Architectural Review  
and Historic Preservation Board  
Special Memo

File: AR 19-15

RE: AR 19-15 (Sloop Medical Building)  
Jan Court at Forest Avenue -- APN 002-210-066 et al.

**A-3**

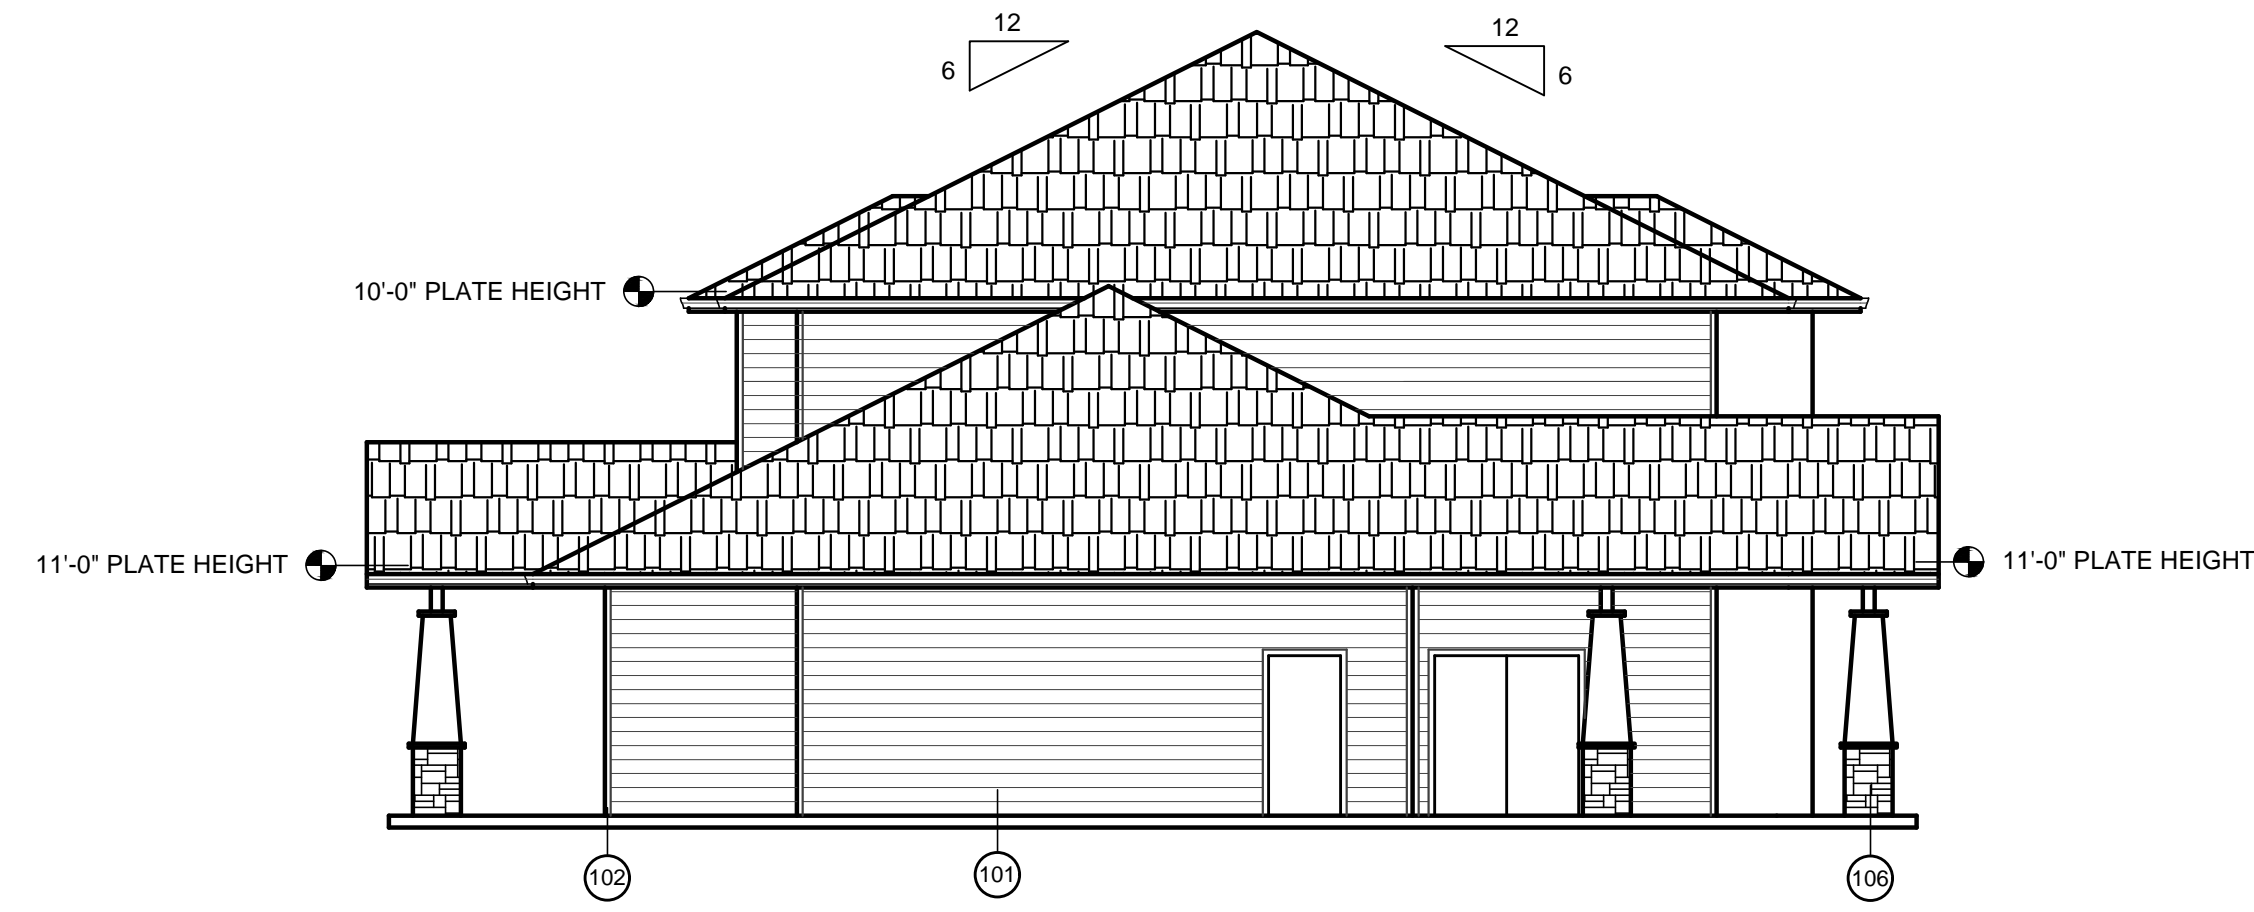
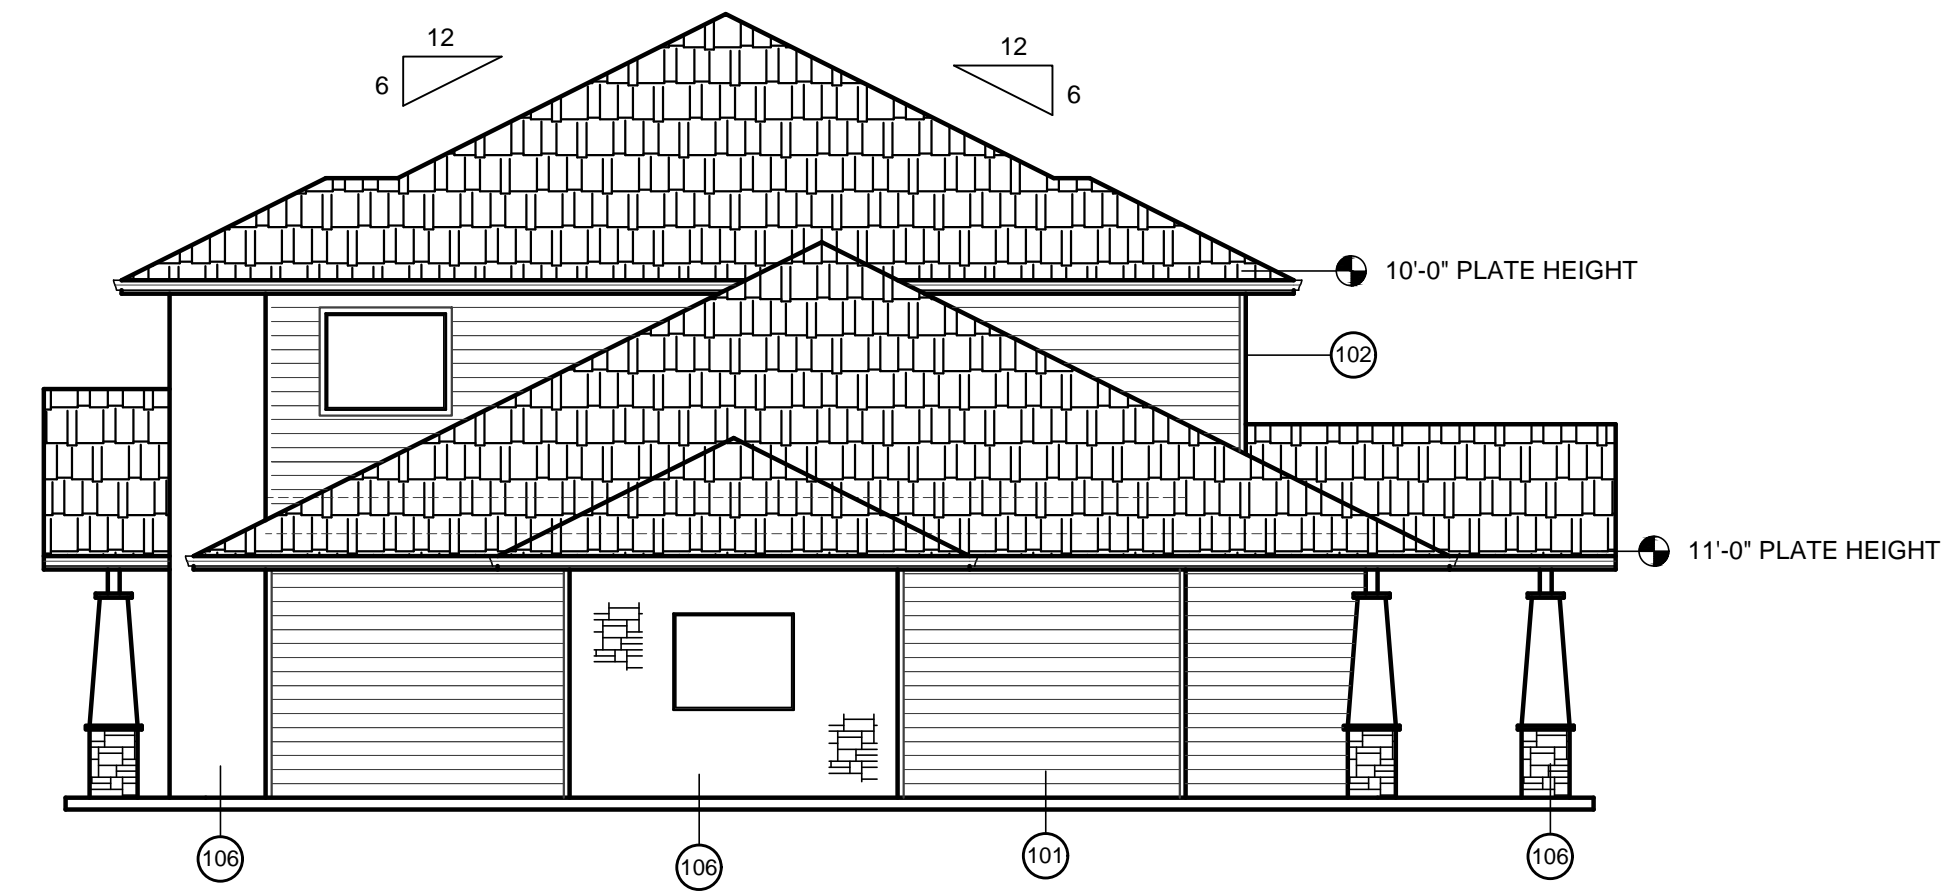
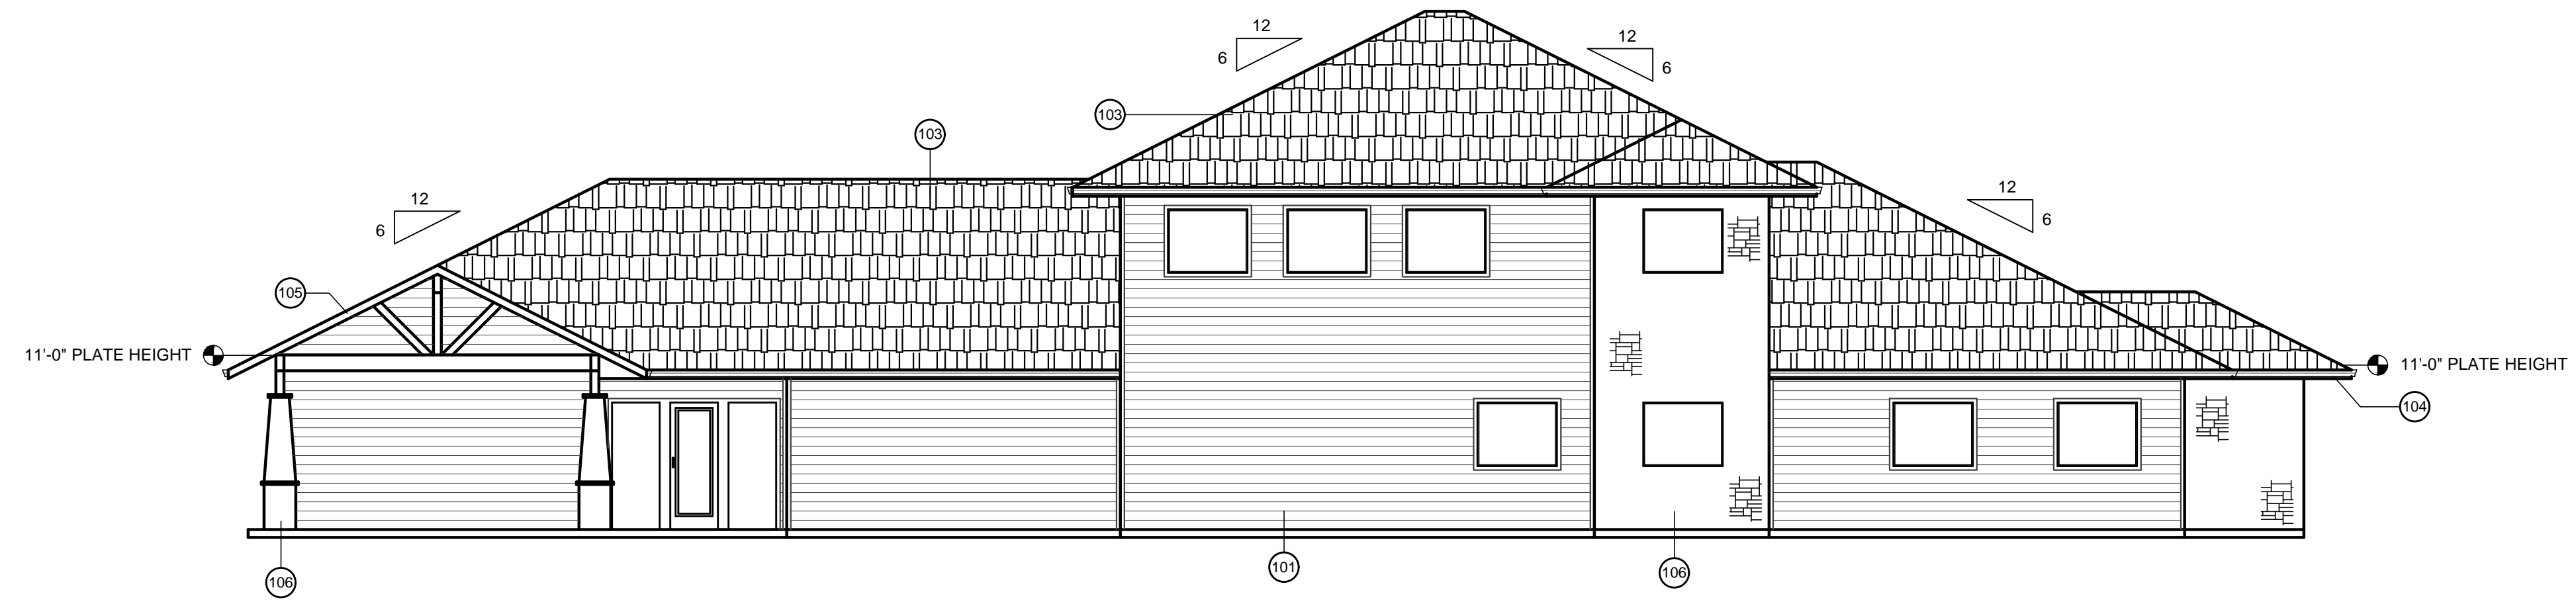
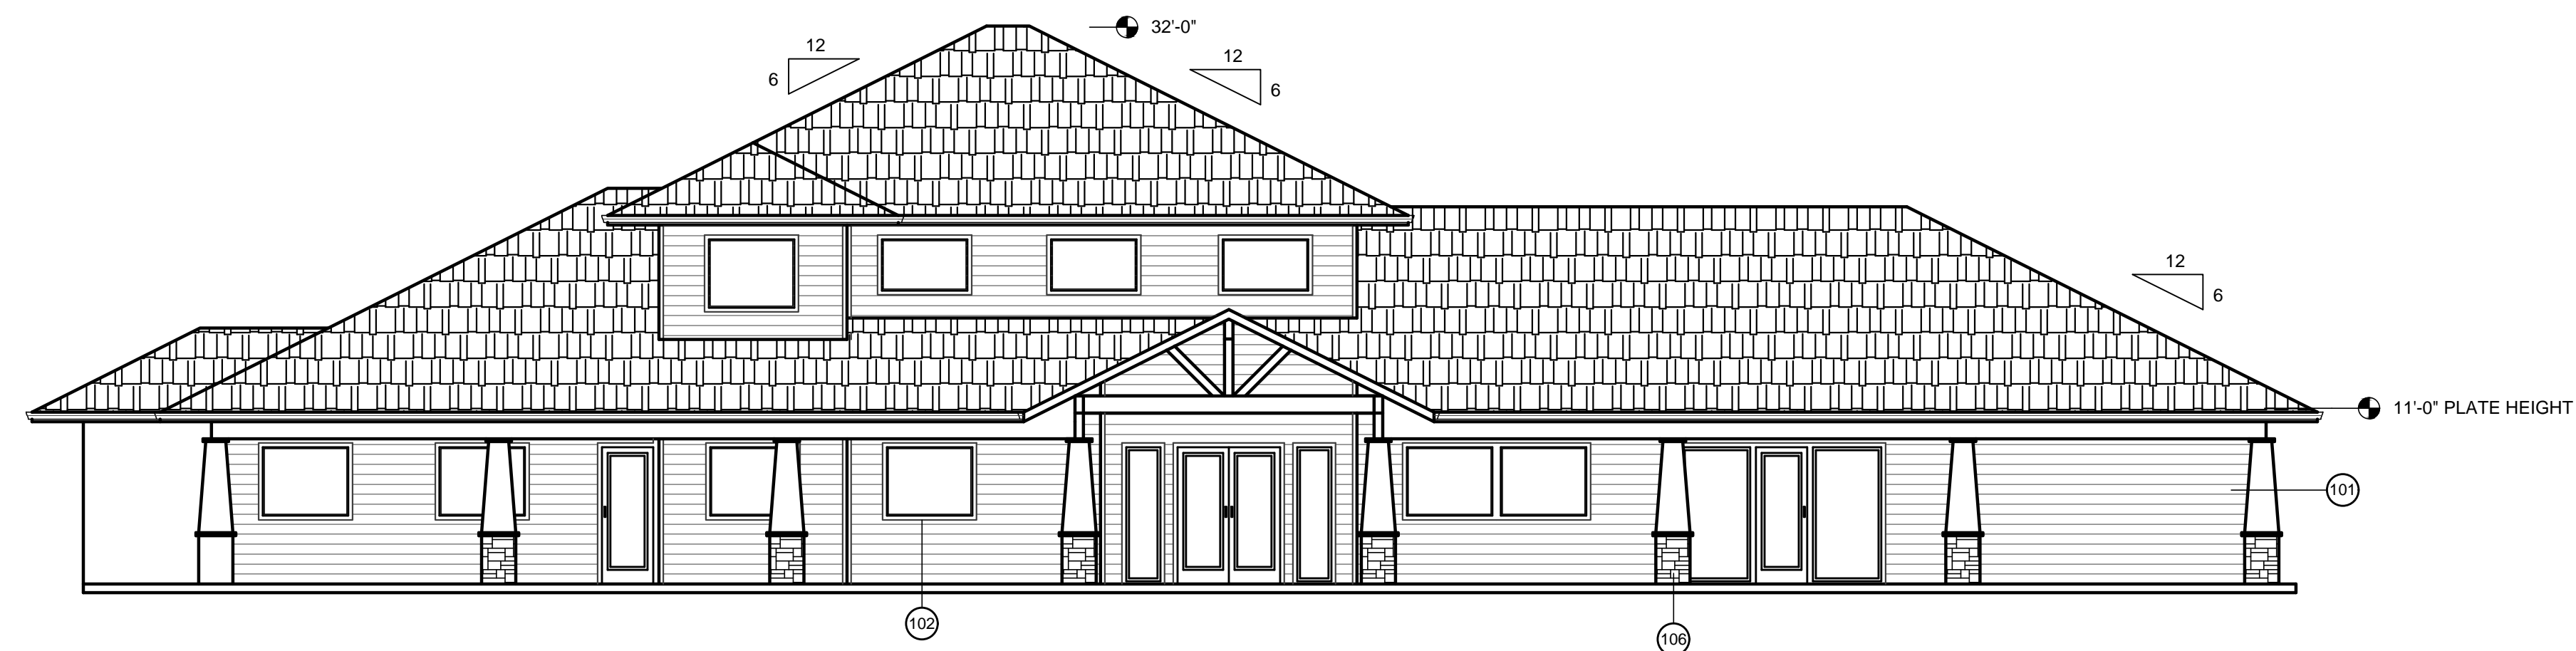
1. Rendering of landscaping, if possible
2. Detailed colored elevations emphasizing the logic and coordination of the color scheme
3. Details of the window trim
4. Materials specified in a clear manner

The applicant provided a revised rendering of the structure consistent with #2 and #3, provided here as **Attachment C**, and stated that the colors, Sherman Williams SW6421 (“Celery”) and trim in Sherman Williams SW7008 “Alabaster White” were those that matched the physical color board, **Attachment G**.

The proposed building would have a modern appearance (see **Attachment C**, Rendering) with some rustic-looking highlights. The primary entrance would be on the north side of the building, distinguished by a grand entrance portico. All elevations would share a blue-and-buff color scheme (see **Attachment D**, Color Board), with tasteful faux-structural elements visible at gable ends. The building is simple, traditional, and professional.

LANDSCAPE PLAN PLANTING PLAN (Forest/Jan)

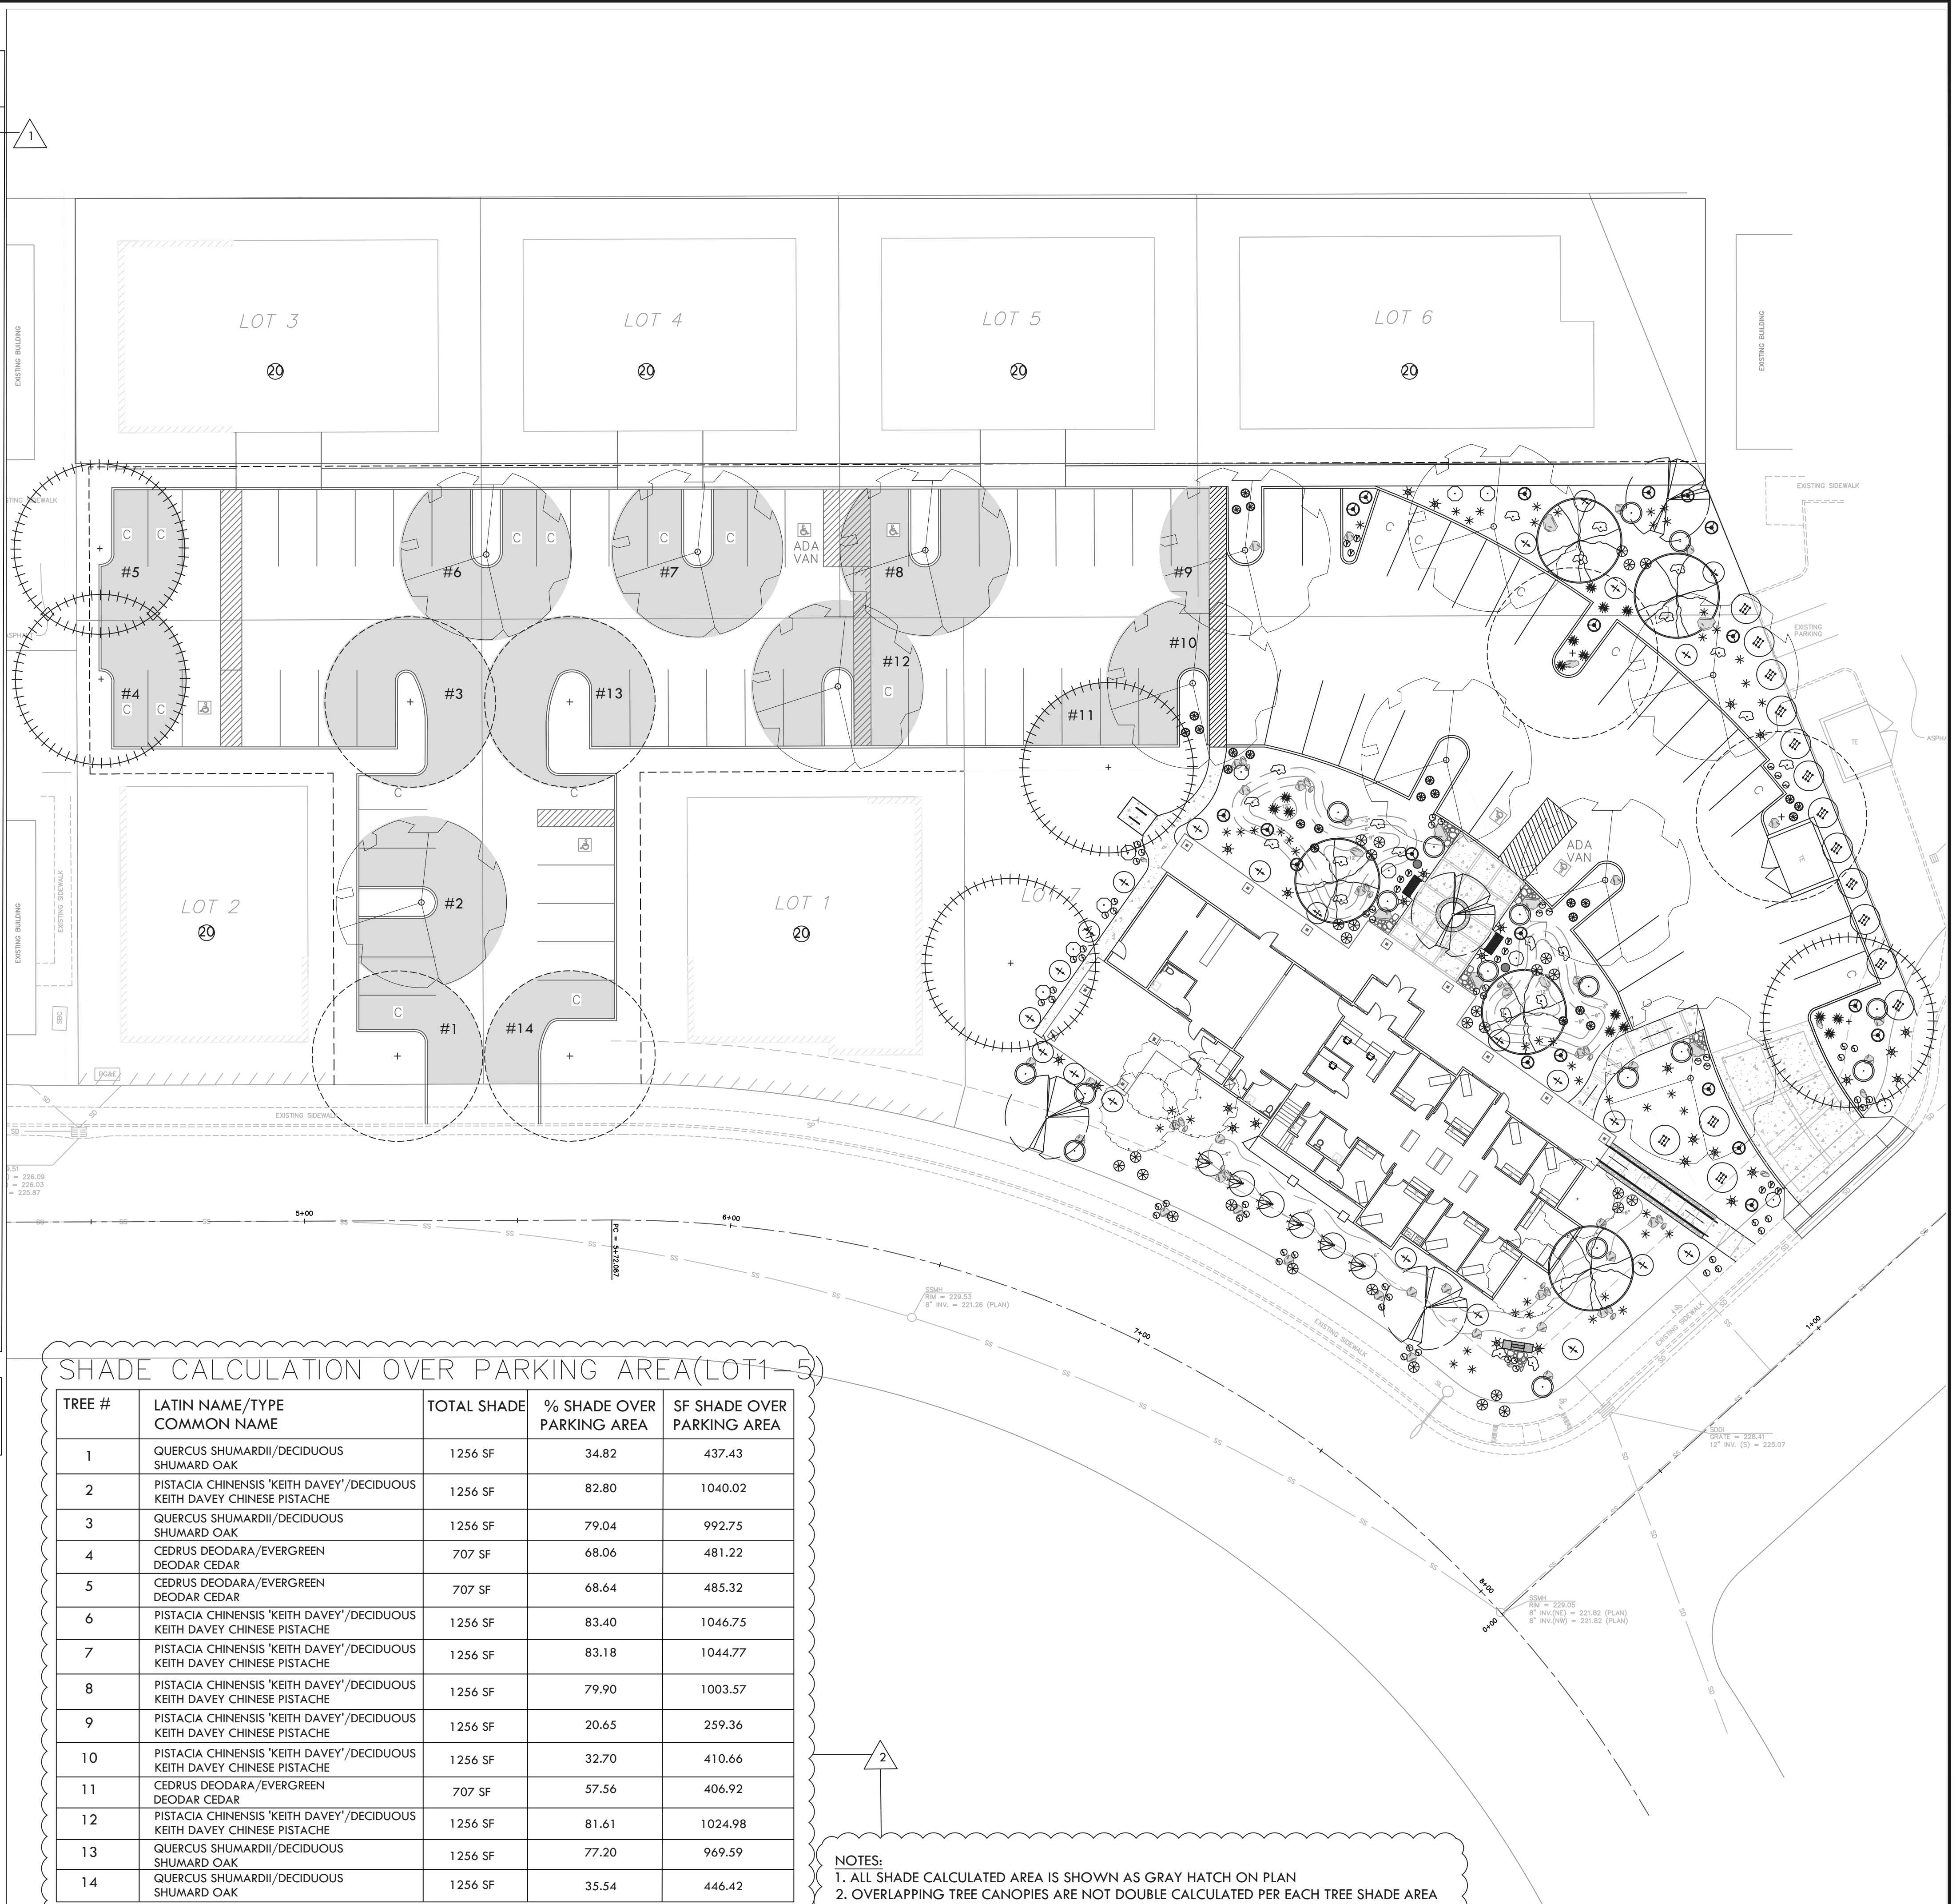
The conceptual landscape plan proposes a variety of trees including deodar cedar and toyon, but no tree would predominate near the structure (see **Attachment E**, Landscape Plan). Shrubs and groundcover would meet the City's requirements, and eight new street

trees would be planted as well. Condition #5 has been added to require landscaping of the entire parking lot concurrent with its construction, so that parking lot shade and other landscaping requirements are met. A new trash enclosure would be located northeast of the building. The enclosure would be CMU block covered with a metal shed roof. Condenser units would be ground mounted on the side of the building facing Forest Avenue, screened by a wall appropriate for the commercial context.

The proposed landscaping will provide visual relief around the new parking area, and the substantial variety of new trees will be an important contributor to the proposed development. The variety of trees selected will provide an attractive environment with water use patterns that meet the city's requirements. Requiring the landscaping of the entire parking lot now will help to ensure that the property is visually appealing even if other parcels are not developed immediately.

5. Prior to issuance of a Certificate of Occupancy the applicant shall install landscaping for the subject parcel (APN 002-210-066), and throughout all parts of the parking area constructed concurrently as shown on the landscape plan. These landscape improvements shall be shown on the building plans and shall comply with City of Chico Municipal Code standards, including the provision of irrigation. Such landscaping shall include all tree cover required for the parking area's shade.
